Re: Draft Environmental Impact Report for the South Bay Substation Relocation Project, Chula Vista, California

The San Diego National Wildlife Refuge Complex (Complex) has reviewed the draft Environmental Impact Report (EIR) for the South Bay Substation Relocation Project located in Chula Vista, California. We offer the following comments for your consideration.

Figure A-2: Overhead 138/230 kV Facilities Schematic
 Bayfront Enhancement Alternative
 (Page 3 of 3)

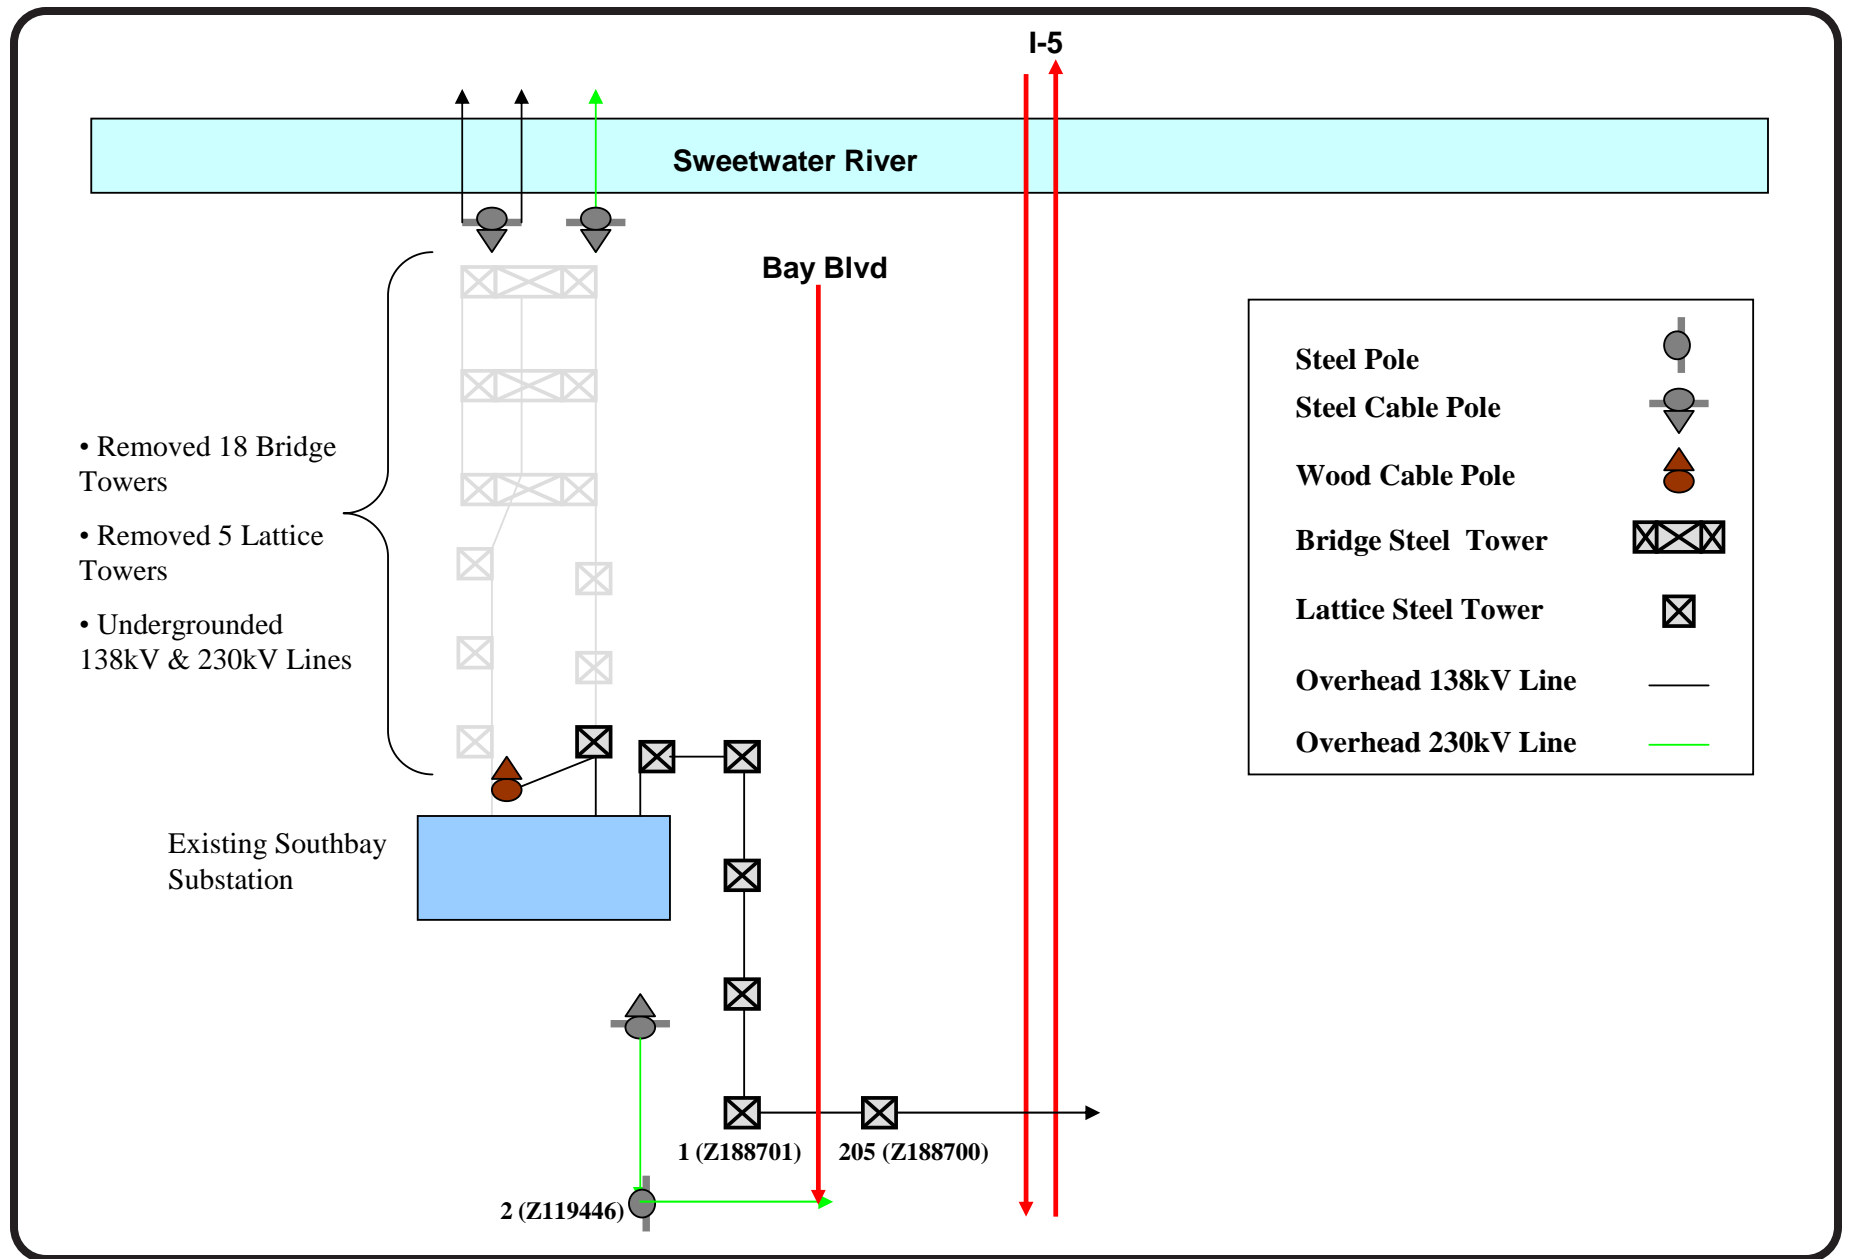
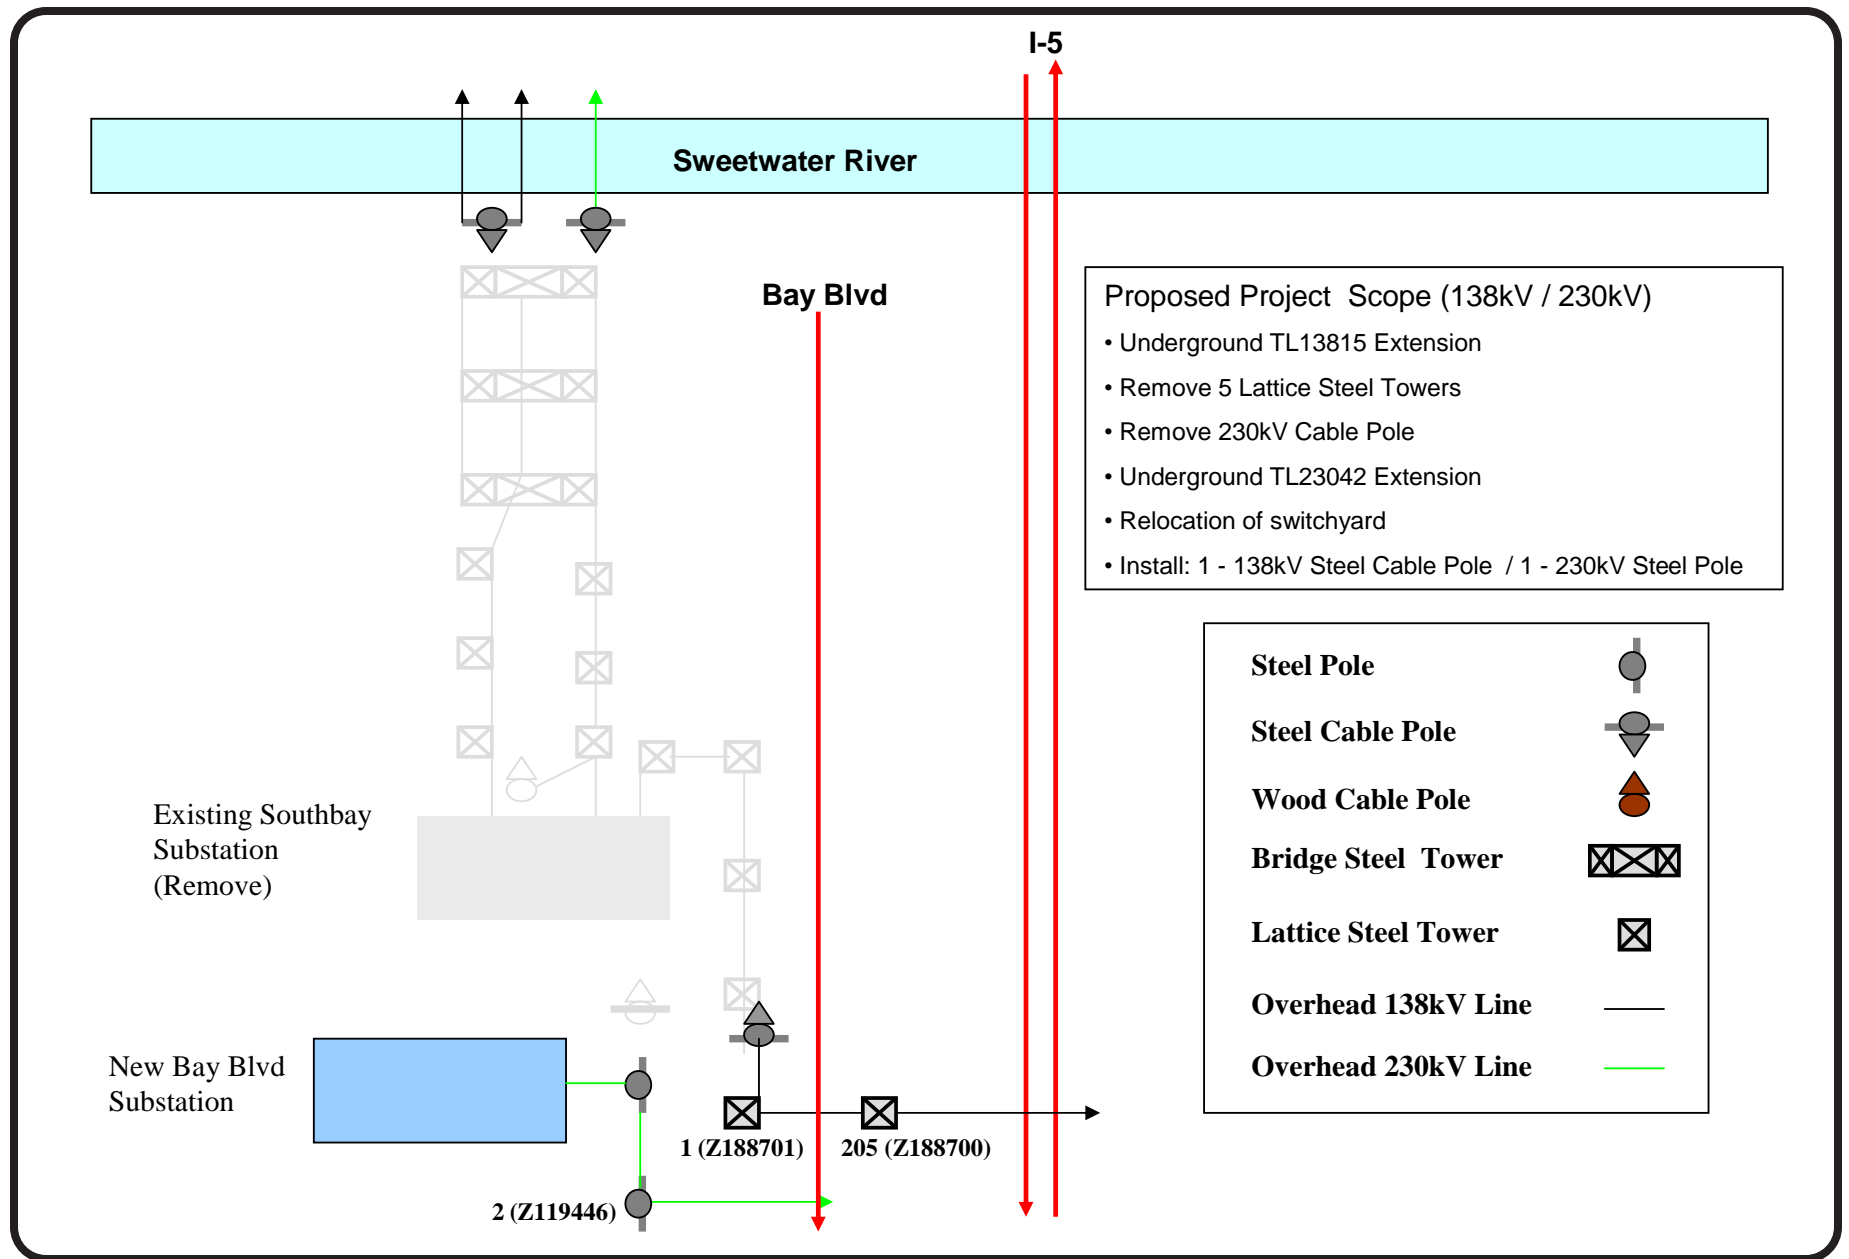
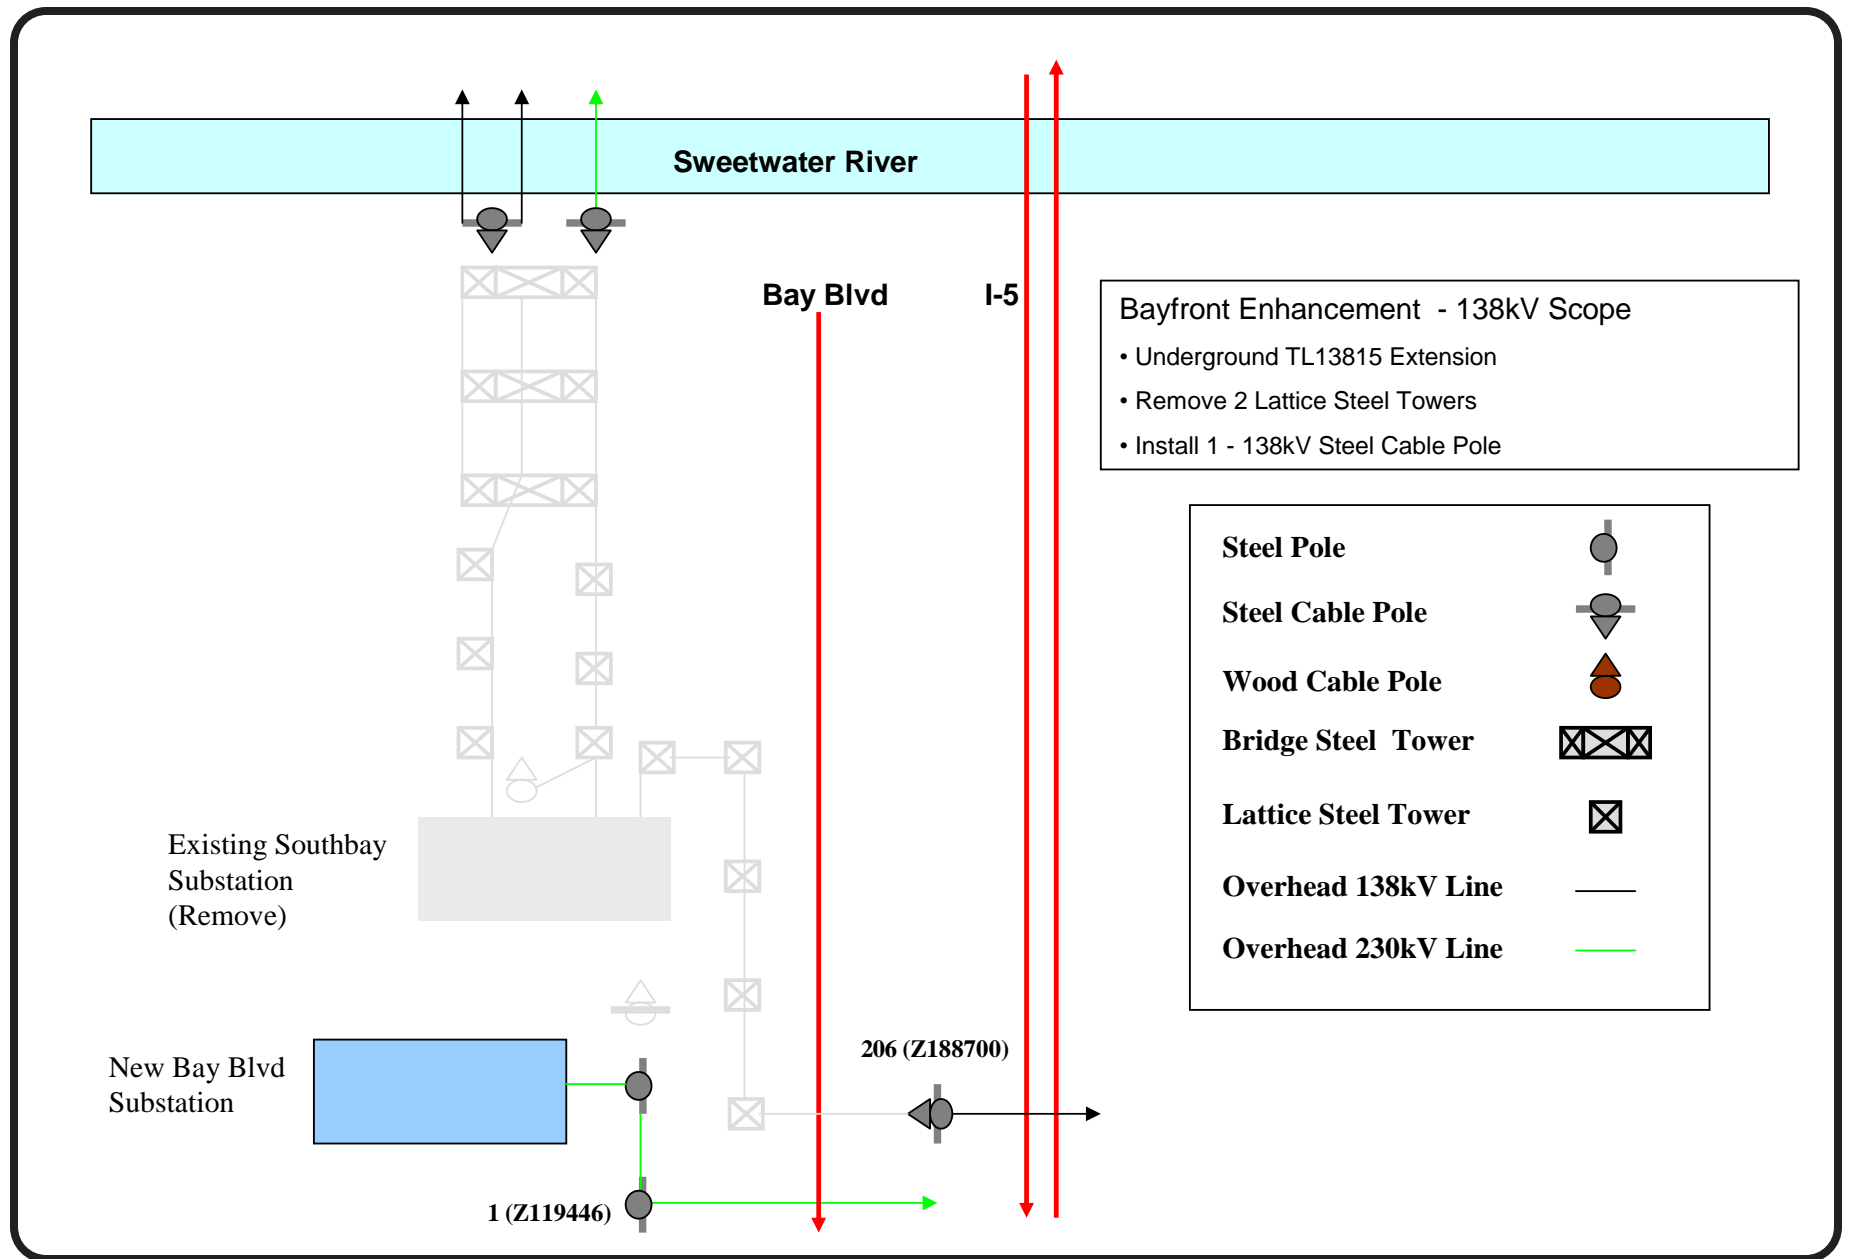
58.	D.2-42	Paragraph 3	Overall, the project would install 19 new poles, remove 36 existing poles, and replace 23 existing poles (9 existing poles would remain on site). A comparison of the existing and proposed 230 kV and 138 kV transmission structures is depicted on Figures B-9 and B-11, respectively (typically poles associated with the proposed 69 kV system improvements are depicted on Figures B-12 and B-13).	A total of 18 new poles would be installed, rather than 19. The text should be revised globally as needed.
D.4 – Air Quality

Figure 2: Enhancement Projects Location Map

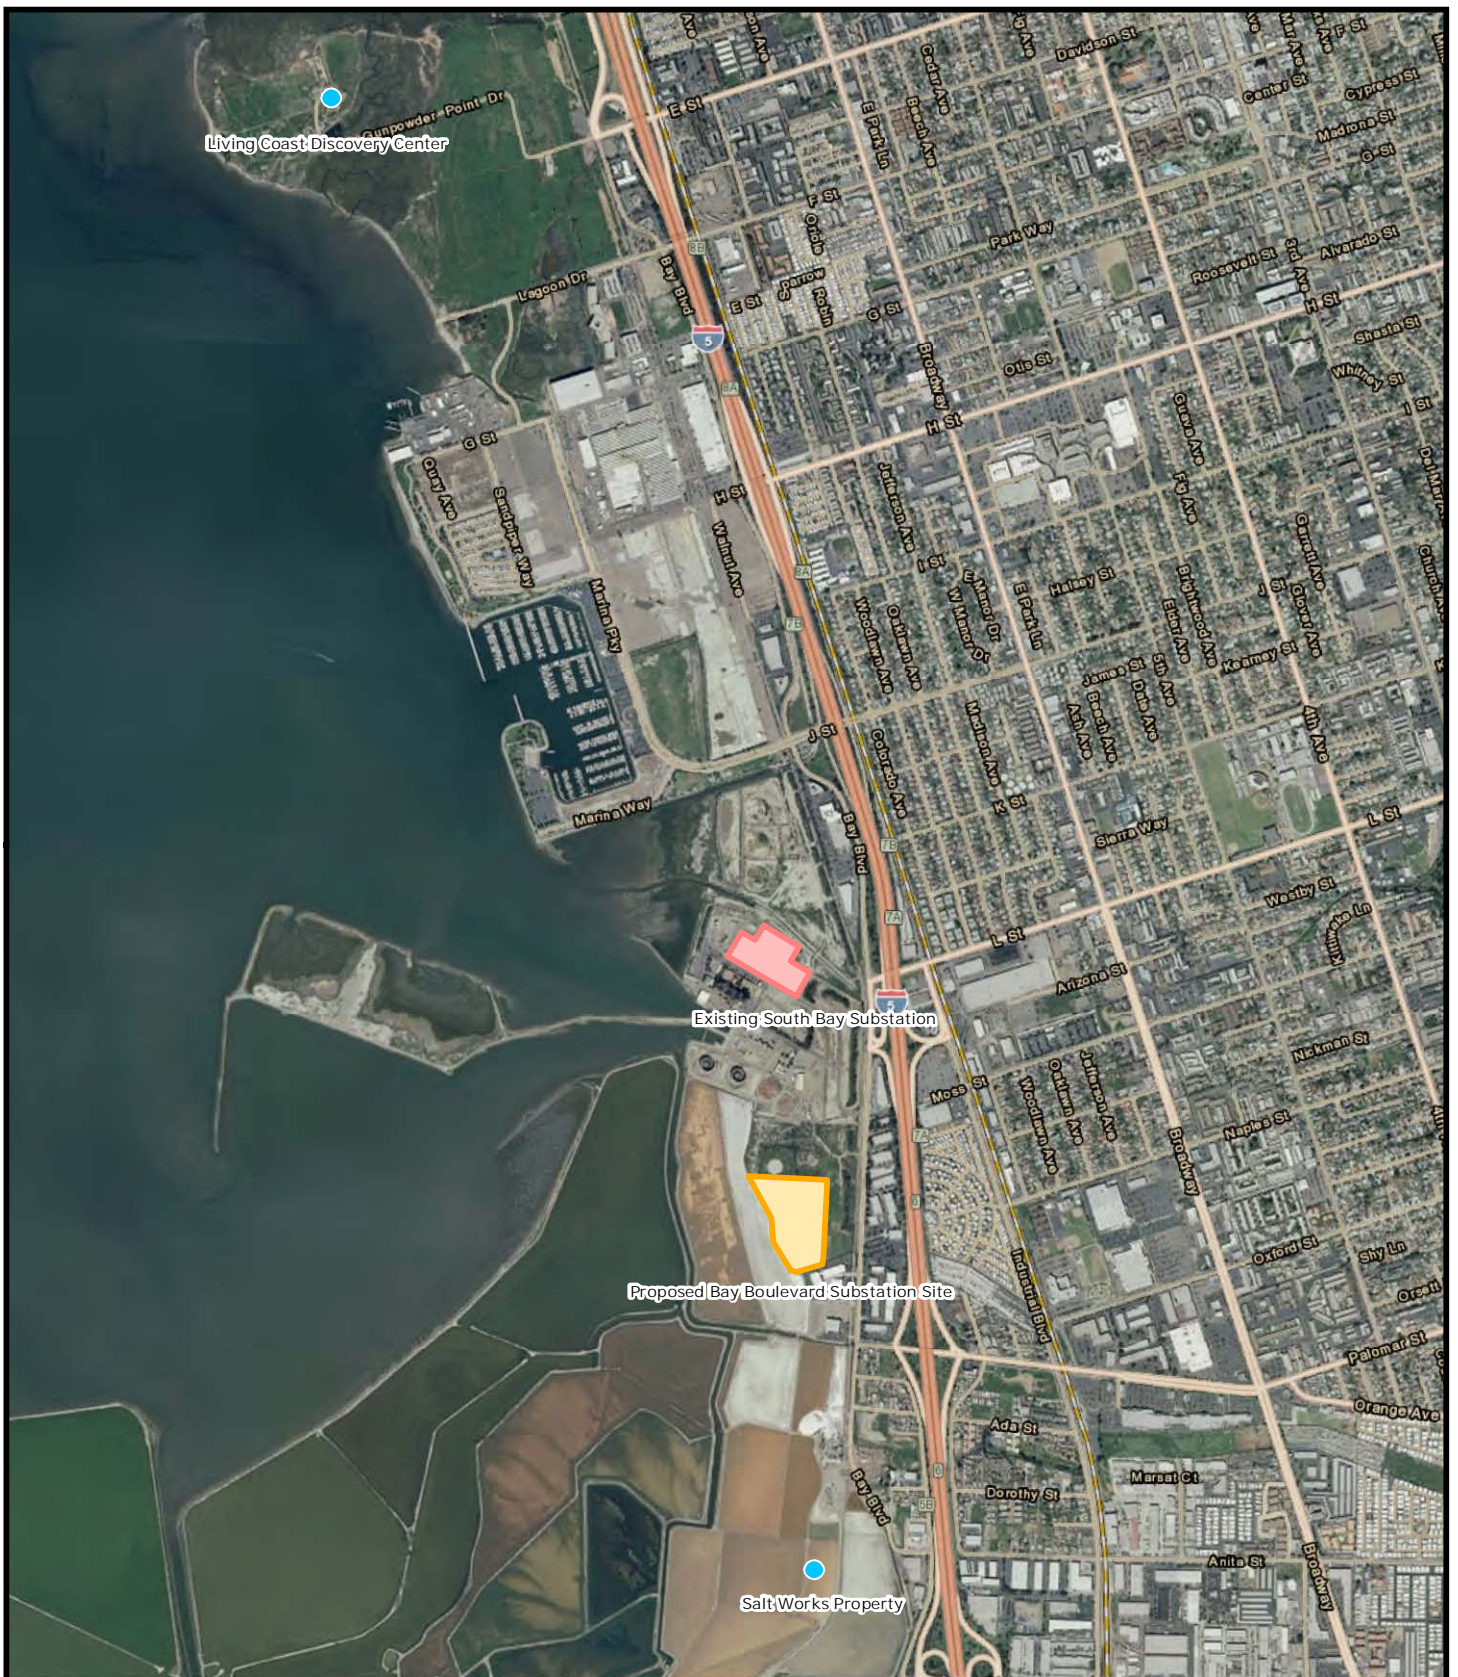
Through coordination with the USFWS, SDG&E has identified actions that would provide opportunities to enhance coastal habitat for breeding, migratory, and wintering birds in the San Diego Bay. The Salt Works property is located approximately 0.6 mile south of the proposed Bay Boulevard Substation site, as depicted in Figure 2: Enhancement Projects Location Map. These actions are described in the following subsections.

As provided in Section 2.1.1 Implementation, the Center is an existing nature Center that provides a living-museum experience while promoting coastal resource conservation and environmental stewardship through education. Figure 2: Enhancement Projects Location Map depicts the location of the Center in relation to the Bayfront Enhancement Alternative site. Providing funding to assist with the continued operation of the Center would not result in any new impacts to resources because the funding provided by SDG&E will allow the Center to continue to operate at existing levels within an existing buildings and facilities. No expansion of the Center would be funded by SDG&E's endowment. Funding the continued operation of the Living Coast Discovery Center would offer the sustained low-cost visitor-serving benefits that are provided by the Center, including an opportunity for the public to access coastal marsh areas that would not otherwise be available, and exposure of the public and schoolchildren to the Bay's wetland and marsh habitats and wildlife for coastal recreation and educational opportunities. Contributing funding to the Center would comply with state and local policies, including complying and advancing the policies established in the California Coastal Act. In addition, as previously noted, this funding would help protect and encourage the continued benefits that the Center offers by providing a lower-cost visitor/recreational facility for the public, in furtherance of Section 30213 of the Coastal Act, resulting in a net benefit to recreation.
